Docket Item #8A&B
Development Special Use Permit #2010-0028
TMP Special Use Permit #2011-0002
The Madison (Amendment to DSUP #2007-0005)

Purpose of Application
A consideration for requests to perform the following: <ol style="list-style-type: none"> 1. Amend development special use permit #2007-0005 for an adjustment in mix of uses, small increase in floor area, open space and building design enhancements; 2. Amend the Transportation Management Plan special use permit #2007-0051; and 3. Parking reduction special use permit.
Staff Recommendation: APPROVAL WITH CONDITIONS
Staff Reviewer(s): Dirk H. Geratz, AICP; dirk.geratz@alexandriava.gov Colleen Willger, AICP, LEED AP BD+C; colleen.willger@alexandriava.gov

DSUP #2010-0028
SUP #2011-0002
The Madison

Original 2007 Approved Open Space Plan

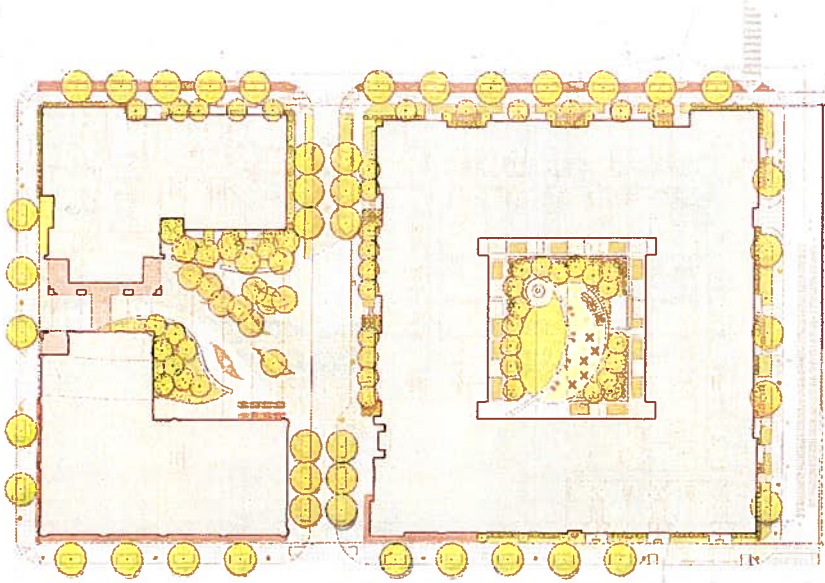
The design of the two courtyards have been revised to make them not only more attractive but more functional as well. The southern courtyard, which will retain a public access easement, has been improved by making the usable area all at the same grade as opposed to the previous plan which included terraced areas. Also, the planting areas have been

The northern courtyard has been improved with added landscaping and also enlarged by an additional 1,556 square feet to make it a more attractive amenity for the units that face onto it. Additional seating areas, an artificial turf area to sit on and an outdoor service bar for outdoor functions have been added. (*See attached drawings for revised open space plans*)

ATTACHMENT #1

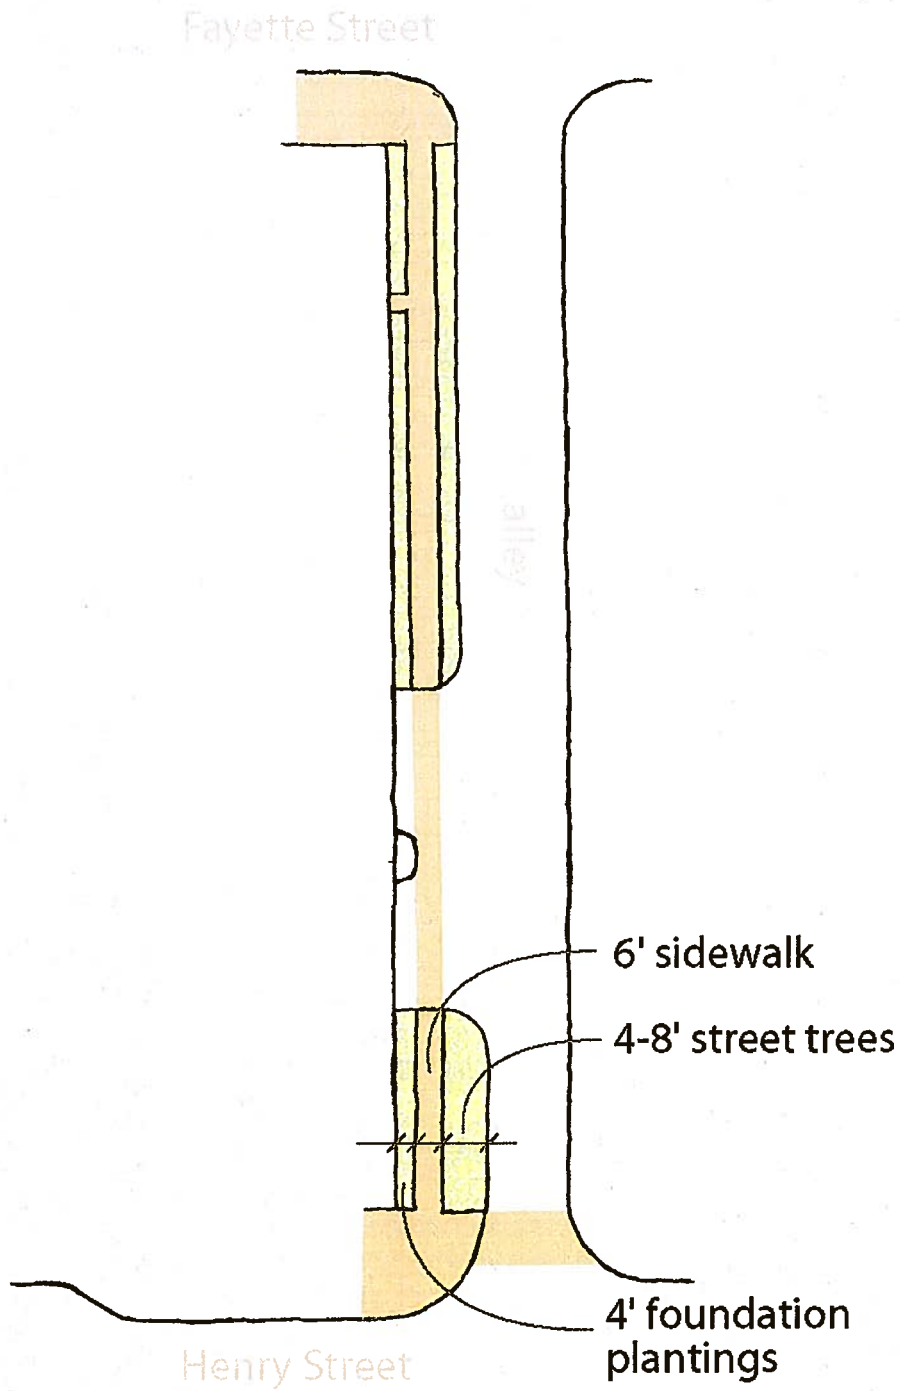
- j. The sidewalks shall include 4 ft. x 12 ft. tree wells adjacent to the curb, a 6 ft. wide unobstructed city standard concrete sidewalk and a minimum 8 – 12 ft. wide landscaped area as depicted in Attachment #1. The deepest front yard setback shall be no less than 12 feet.
- k. The sidewalks on Fayette Street shall be City standard concrete and shall comply with City standards.
- l. This facade shall have three (3) entryways and doors directly to the adjoining sidewalk and be architecturally designed to appear as entryways.
- m. Provide special paving patterns and materials to designate the residential entrance at the corner of Fayette and Madison Streets.
